BY Trans-Tasman Resources Limited

**SUPPLEMENTARY EVIDENCE OF DARRAN HUMPHESON (ACOUSTICS)
ON BEHALF OF TRANS-TASMAN RESOURCES LIMITED IN RESPONSE TO
DR MATT PINE'S PEER REVIEW**

21 NOVEMBER 2025

Figure 2 : Distance reduction relationship between different solutions

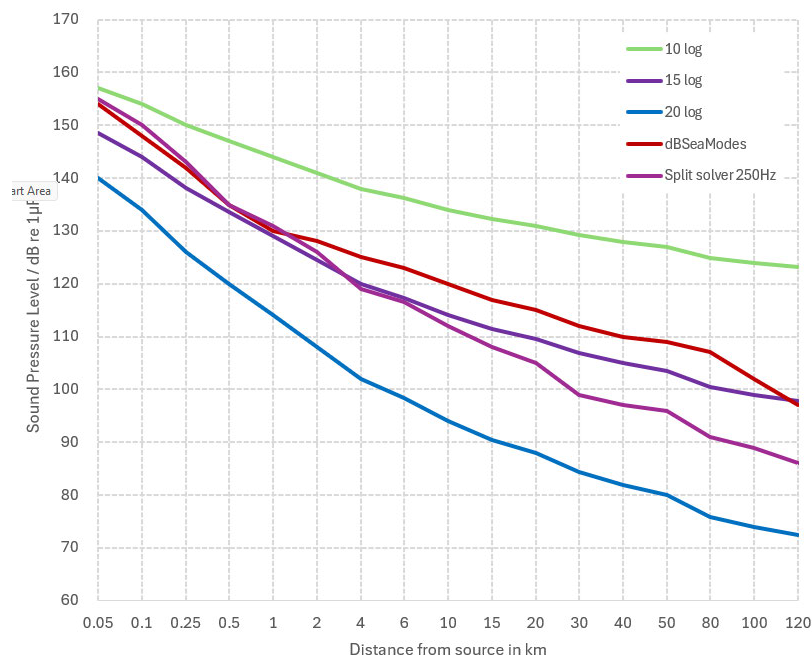
32. To further demonstrate the sensitivity of receiver levels to different cross-over frequencies I have generated a similar distance-reduction analysis to that provided to the 2017 Hearing¹¹. This analysis uses the latest TTR dBSea model with a combined source level of 177 dB re 1µPa at 1m (Condition 12), and the outputs of six solver solutions:

35. This combined approach ensures that the sound propagation modelling reflects the most accurate transmission loss behaviour across the full frequency spectrum relevant to marine mammal hearing. It is important to note that this method results in slightly greater transmission loss at longer ranges (> 1km) compared to a single-solver approach (as shown in Figure 2 above), due to the differences in how each solver handles energy propagation. However, I considered this trade-off acceptable because the primary objective was to improve accuracy for frequency-weighted assessments rather than maintain the conservative bias of the earlier unweighted analysis. This change also explains why Dr Pine identified differences in the noise contours between 2017 and 2025.¹⁴ These differences are a direct result of the change in calculation algorithm and not for any other reason.
